# SERVICE BULLETIN

NON-MODIFICATION SERVICE BULLETIN — HIGH PRESSURE TURBINE  
STAGE 2 AIR SEAL — REPLACEMENT OF

V2500 Series 72-0676

**V2500-ENG-72-0676**

LOCATION OF STAGE 2 HIGH PRESSURE TURBINE AIR SEAL  
72-45-00  
FIGURE 1

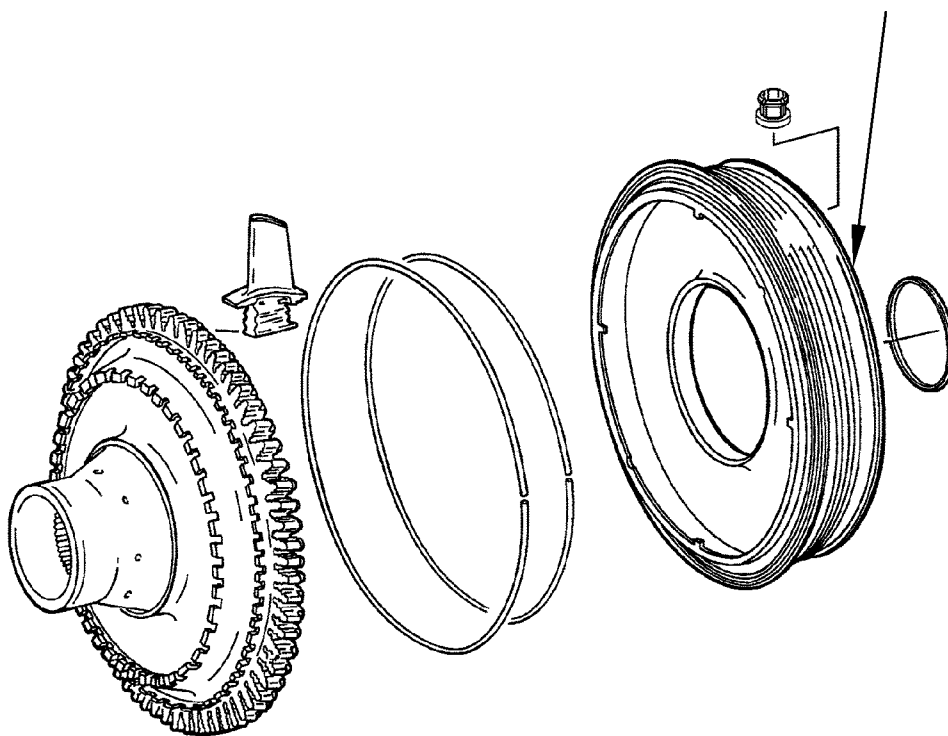
1. Remove the HPT Stage 2 Air Seal, PN 2A4157, listed by serial number and cycle limit specified in Table 1. See Figure 1. Reference 5 or 6, Engine Manual, Chapter/Section 72-45-00.
2. Install a new HPT Stage 2 Air Seal, PN 2A4157 when you assemble the HPT rotor and stator assembly. Reference 5 or 6, Engine Manual, Chapter/Section 72-45-00.
3. Recording Instructions
  - A. A record of accomplishment is required.

PN 2A4157 STAGE 2  
HIGH PRESSURE TURBINE  
AIR SEAL REPLACE AS  
SPECIFIED IN TABLE 1.

Accomplish replacement of HPT Stage 2 Air Seal, PN 2A4157 identified by serial number and cycle limit specified in Table 1.

Serial Number	Threshold
PKLBN41534	Replace part prior to accumulating 1,236 cycles since new
PKLBN41540	Replace part prior to accumulating 1,572 cycles since new
PKLBN41568	Replace part prior to accumulating 1,281 cycles since new
PKLBN41608	Replace part prior to accumulating 1,483 cycles since new
PKLBJC4871	Replace part prior to accumulating 7,074 cycles since new
